Case No. CD-CPC-2020-00191

Mazuma Credit Union – Rezoning to MPD

Case No. CD-CPC-2021-00011, CLD-FnPlat-2021-00001

The Tracks Apartments – Rezoning to UR, Final Plat

THE TRACKS APARTMENTS
 311 W 22ND ST, KANSAS CITY, MO
 LOT 1

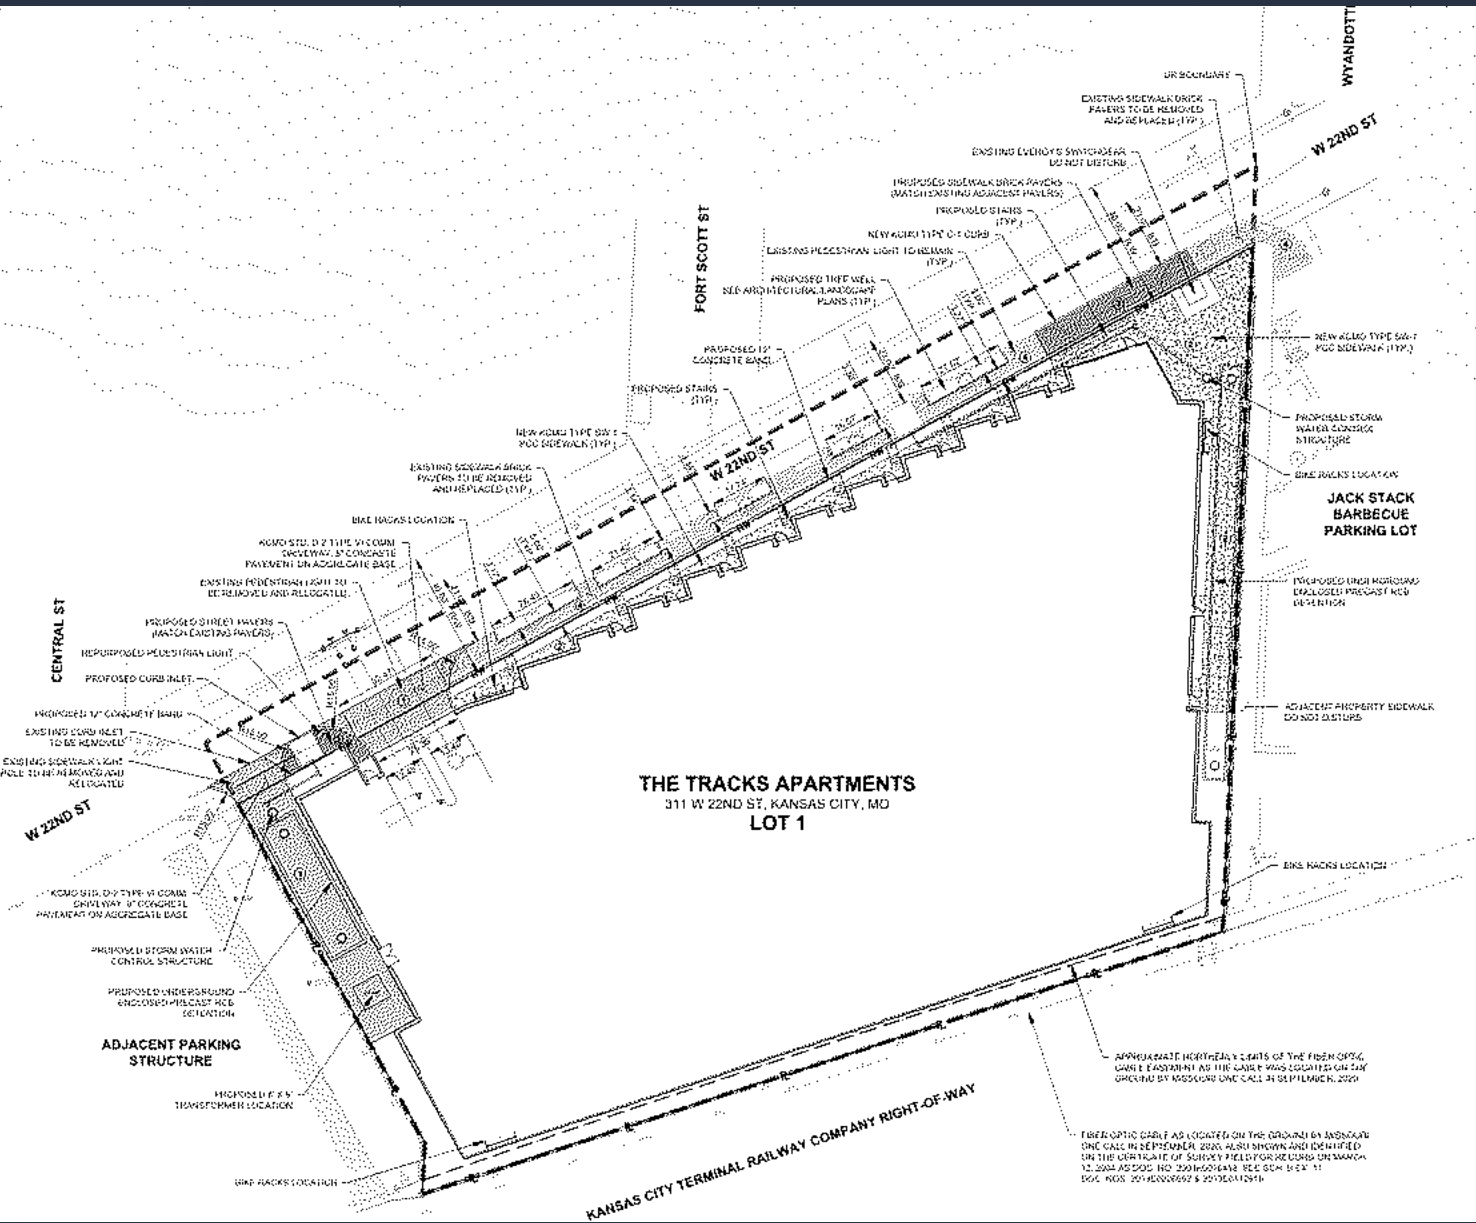
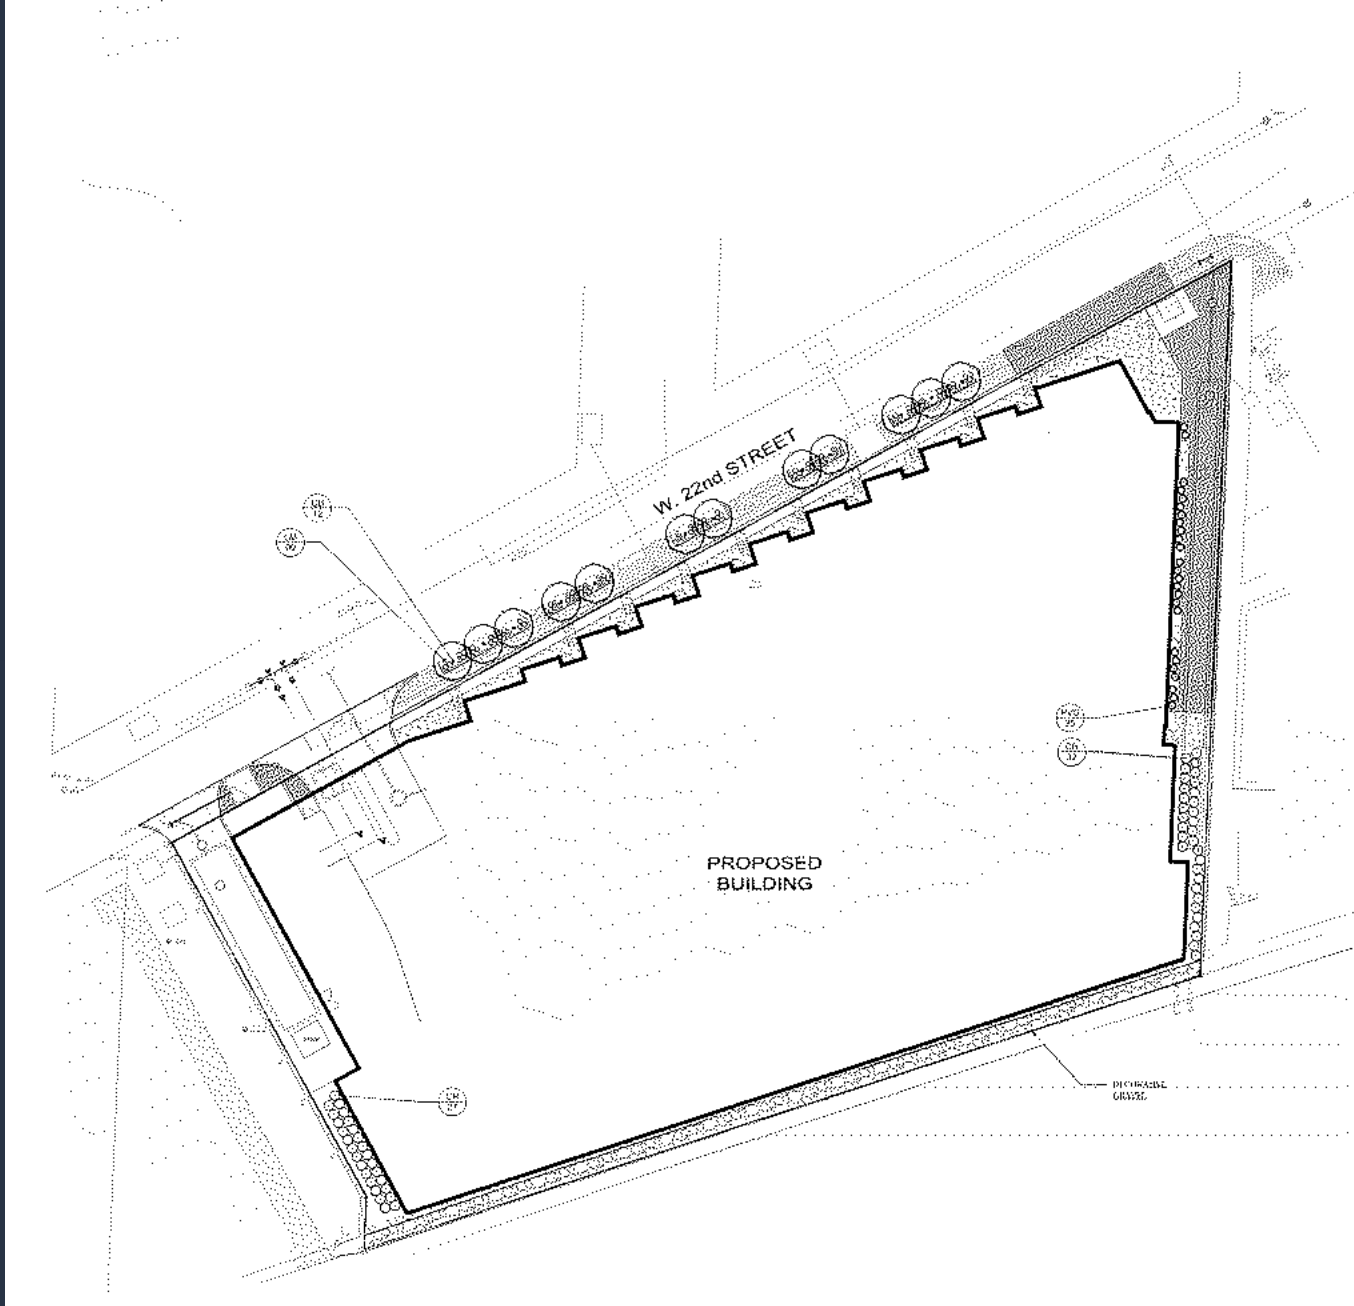
The applicant proposes one vehicular access with both ingress and egress from W. 22nd Street to the garage behind the residential units. A total of 261 parking spaces are provided (111 for unit parking and 150 for shared public and unit parking) and 86 bike parking is provided on site.

The proposed 7-story residential apartments will have 0-foot setback from all property boundaries and fronting W. 22nd Street with diagonal units on the ground and 2nd floors to provide more pedestrian-oriented experience

19. Fire Department access roads shall be provided prior to construction/demolition projects begin. (IFC-2018 § 501.4 and 3310.1; NFPA 241-2013 § 7.5.5) (3/10/2021)

20. Fire apparatus access roads shall have an unobstructed width of not less than 20 feet (6096mm), exclusive of shoulders, except for approved security gates in accordance with Section 503.6, and an unobstructed (3/10/2021)

21. • Aerial Fire Apparatus access roads shall be provided for any building that is 30 feet in height or greater. Aerial Fire Apparatus Roads are a minimum 26 feet wide, at least 15 feet away from the building but not more than 30 feet from the structure. (IFC-2018 § D105) (3/10/2021)

22. • The turning radius for fire department access roads is 30 feet inside and 50 feet outside radius. (IFC-2018: § 505.2.4) (3/10/2021)
23. • Buildings exceeding three (3) stories or 30 feet in height shall have at least two means of fire apparatus access. (IFC-2018: § D104.1) (3/10/2021)

24. • Buildings equipped with a fire standpipe system shall have an operable fire hydrant within 100 feet of the Fire Department Connection (FDC). (IFC2018 § 507.5.1.1) (3/10/2021)

25. • The Fire Department Connection (FDC) shall not be located that obstructs access/egress to the building when in use (IFC-2018 § 912.2). (3/10/2021)

26. • The expectation is the project will meet the fire flow requirements as set forth in Appendix B of the International Fire Code 2018. (IFC-2018 § 507.1) (3/10/2021)

27. • Multi-family residential developments greater than 200 dwelling units shall have at least two separate and approved fire apparatus access roads (IFC-2018 § D106.2) (3/10/2021)

Remove #19, 20, 21, 22, 23, 27
